University Transportation Research Center - Region 2

Final Report

Verification/Development of Seismic Design Specifications for Downstate Zone

NYSDOT Project No: C-09-04
UTRC/RF Grant No: 55505-02-03

Fig. 1.3 Comparison of response design spectra of rock and soil sites for the 1500-year earthquake: (a): rock class A and soil on rock class A; (b) rock class B and soil on rock class B.

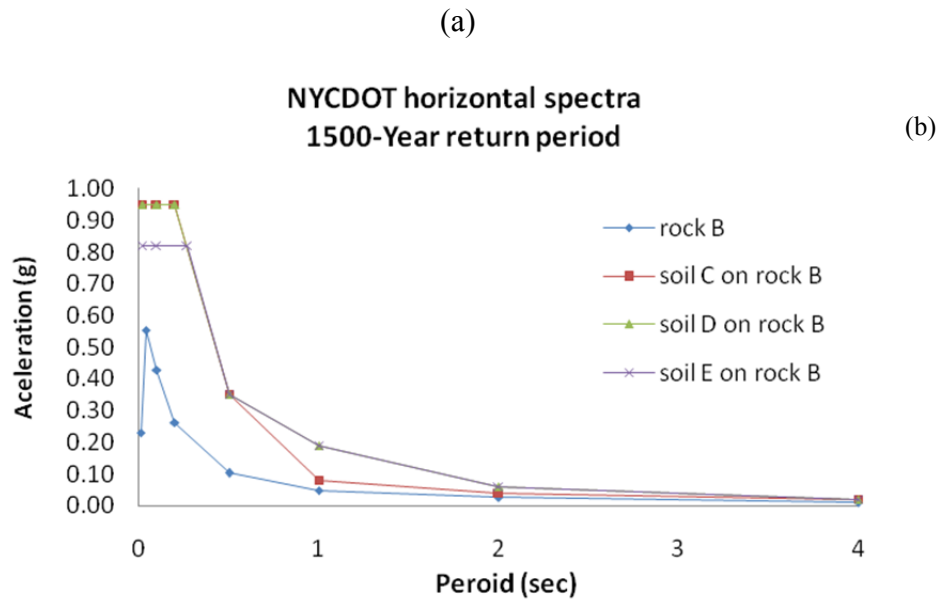
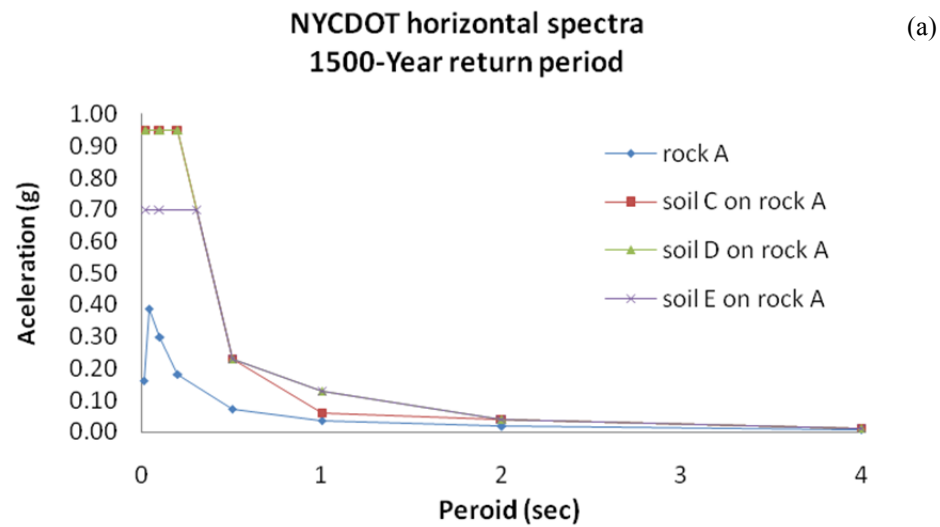
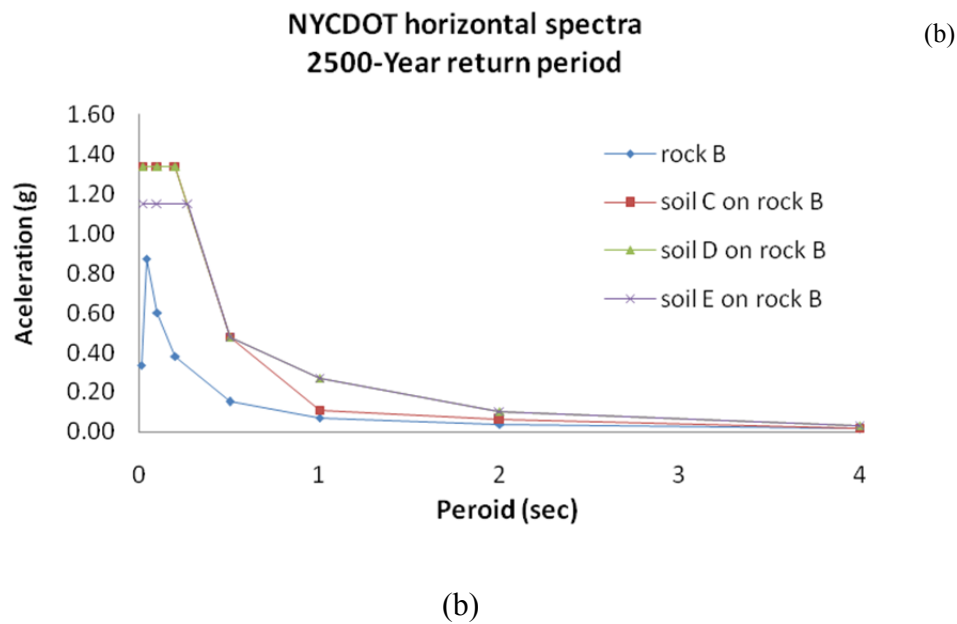
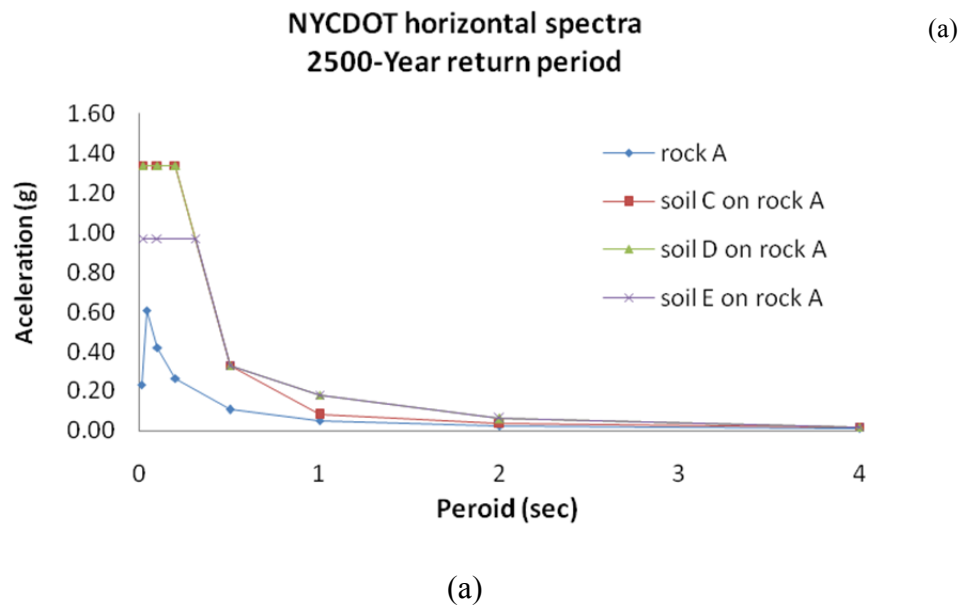
Figs. 1.3 and 1.4 compare the response design spectra on rock and soil sites for two earthquake return periods: 1500 year and 2500 year as proposed in the NYCDOT Guidelines Report. The differences are substantial, as can be expected, and the spectral accelerations at all periods on soil sites ($H_r < 100$ ft) are much higher than those at the rock sites due to soil amplification. The same trend is also observed for the 500-year earthquake.

“A site is classified as a soil site if there is more than 10 ft of soil between the bottom of spread footing or pile cap and the surface of bedrock; otherwise it is classified as a rock site”.

This suggestion has been accepted by NYSDOT.

Fig. 1.7 Deep rock class B profiles analyzed

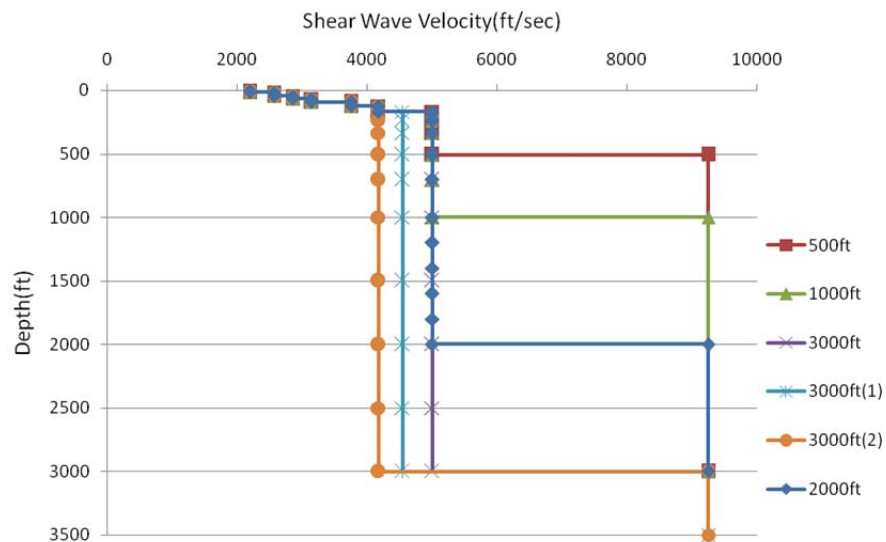
The trend of site factor versus frequency is reversed for thick soft rock profiles above VHR. Since no measured data is available, the existence of any thick soft-rock profile can only be assumed. The Commentary describes analysis of an assumed 3000 ft thick soft rock profile that falls within Rock Class B. The results show site amplifications up to 1.8 at low frequencies (< 1.0 Hz) and values spread around unity at high frequencies (> 10 Hz). The research team conducted Proshake analyses on the same profile described in the

Commentary as well as several other assumed Rock Class B profiles shown in Fig. 1.7. As shown in Fig. 1.8, the results are consistent with those in the Commentary, but also show the dependence of site amplification on the thickness of soft rock and other details of the stiffness profile.

Fig. 1.17 Maximum shear strain in the soil deposits under 2500-year earthquake: (a) soil class C; (b) soil class D; (c) soil class E

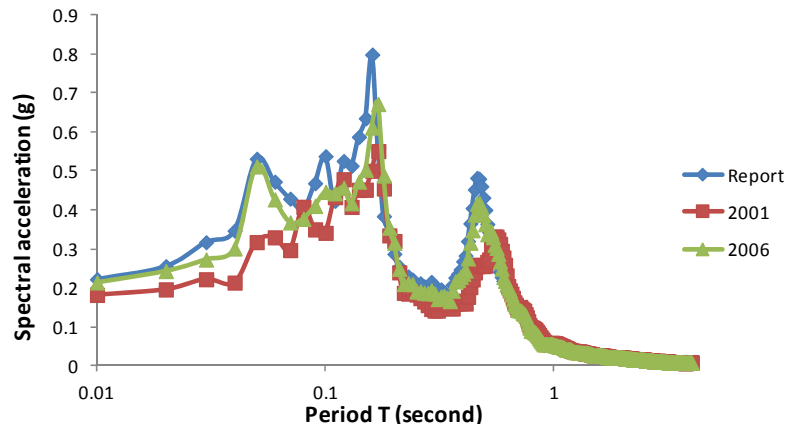
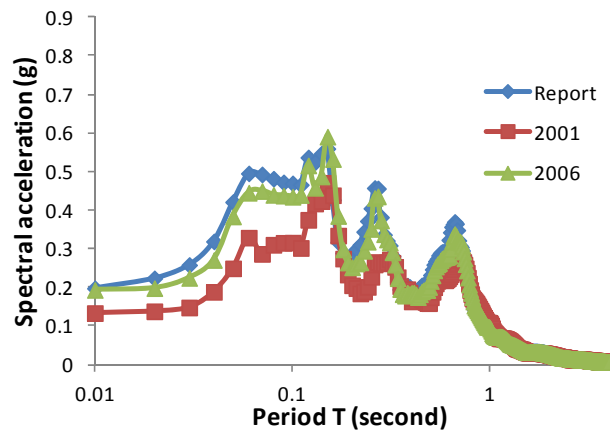
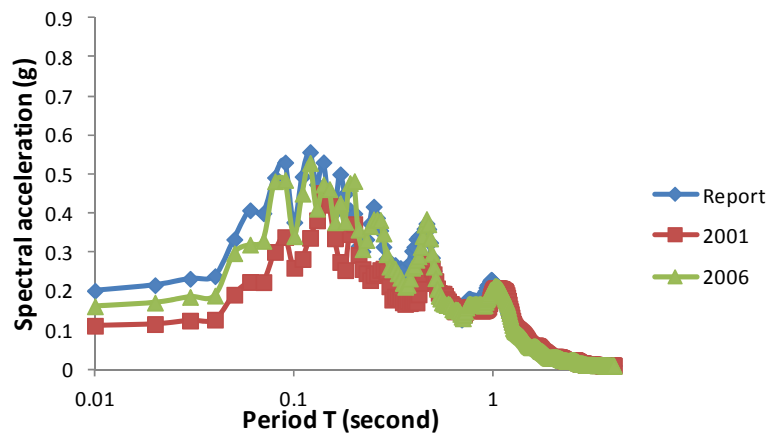
curves are similar at small strains. The small shear strains also indicate that equivalent linear analysis methods are acceptable for developing the horizontal response spectra in the area. The Commentary to the Guidelines should add a note to this effect.
